Technical Service Bulletin: tsb100697

Enlarge Head Gaskets

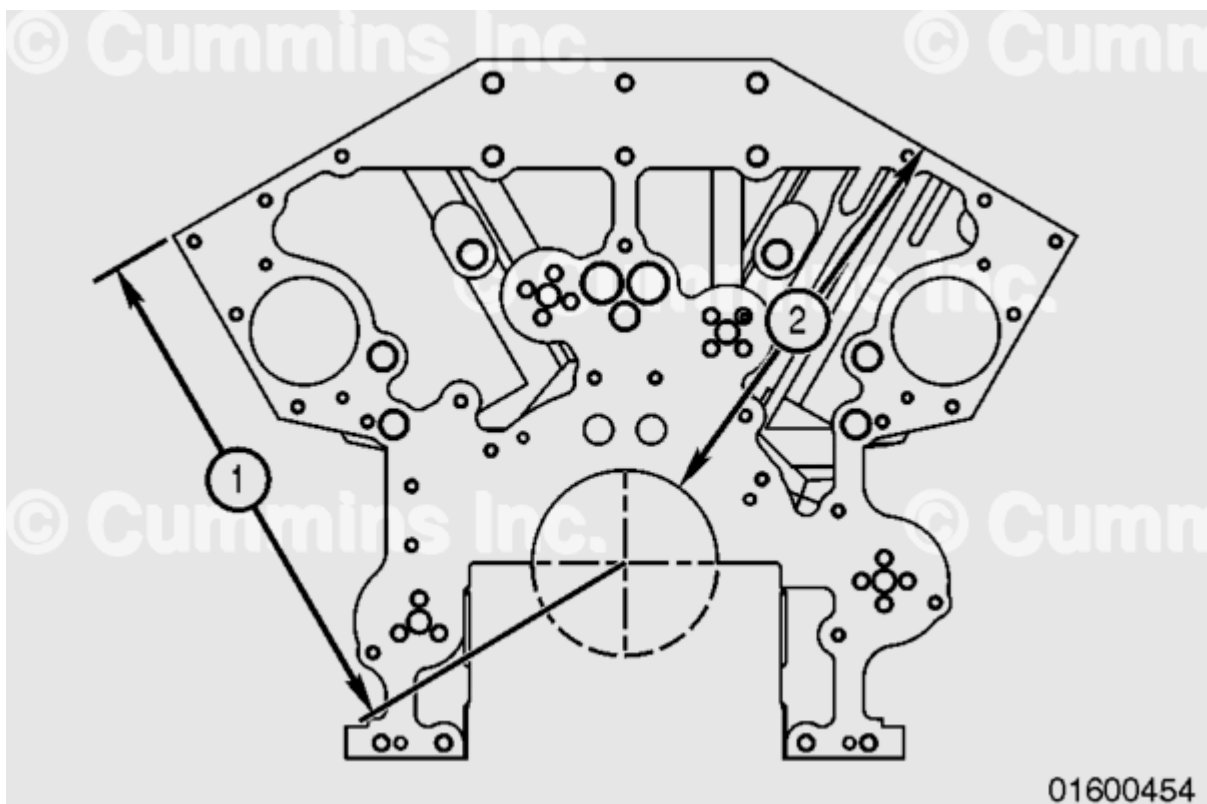
The following dimensions **must** be measured to determine the correct enlarged head gasket to be used:

- Block deck to crankshaft centerline (1)
- Block deck to crankshaft bore (2).

mm		in
From crankshaft centerline:	529.45	MIN	20.844
	529.75	MAX	20.856
From crankshaft bore:	432.97	MIN	17.046
	433.30	MAX	17.059
	mm		in
For 0.010 oversize gasket:	529.20	MIN	20.835
	529.44	MAX	20.844
For 0.020 oversize gasket:	528.94	MIN	20.824
	529.19	MAX	20.834
For 0.030 oversize gasket:	528.69	MIN	20.815
	528.93	MAX	20.824
	mm		in
For 0.010 oversize gasket:	432.72	MIN	17.036
	432.96	MAX	17.046
For 0.020 oversize gasket:	432.47	MIN	17.026
	432.71	MAX	17.036
For 0.030 oversize gasket:	432.21	MIN	17.016
	432.46	MAX	17.026
